**Products Affected:**

DPL305 Pulldown (Serial code BMGP, BJAP) built prior 1/22/2013.

**Diagram 1****Cause:**

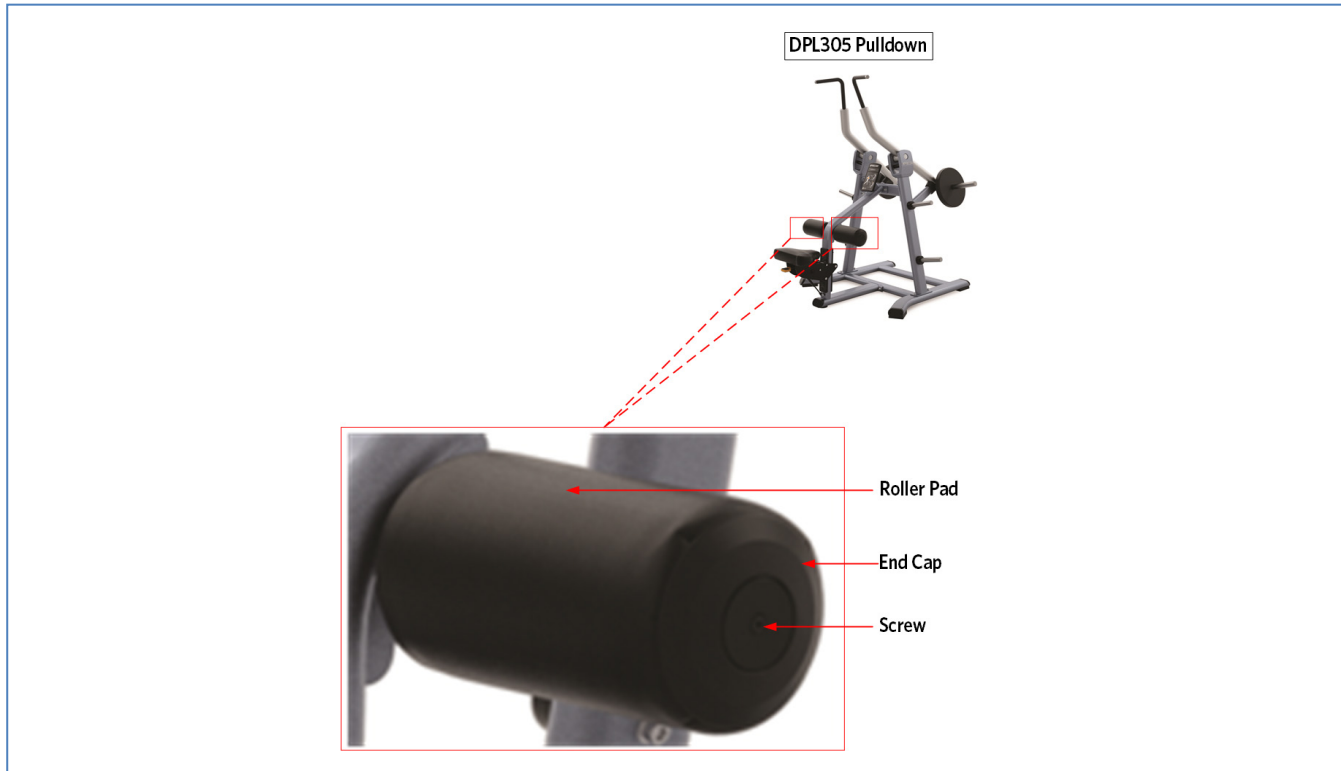
The screw that holds the end caps are coming loose and falling out. **See Diagram 1.**

The roller shaft on units built prior to 1/22/2013 are too short. The short roller shaft causes the round end caps and screw to spin along with the roller pads normal rotating movement, forcing the end caps to become loose and fall out.

The length of the roller pad shaft has been increased to eliminate the issue. If the DPL305 is exhibiting the symptom order and replace the revised shaft, PN PPP000CWP020900101.
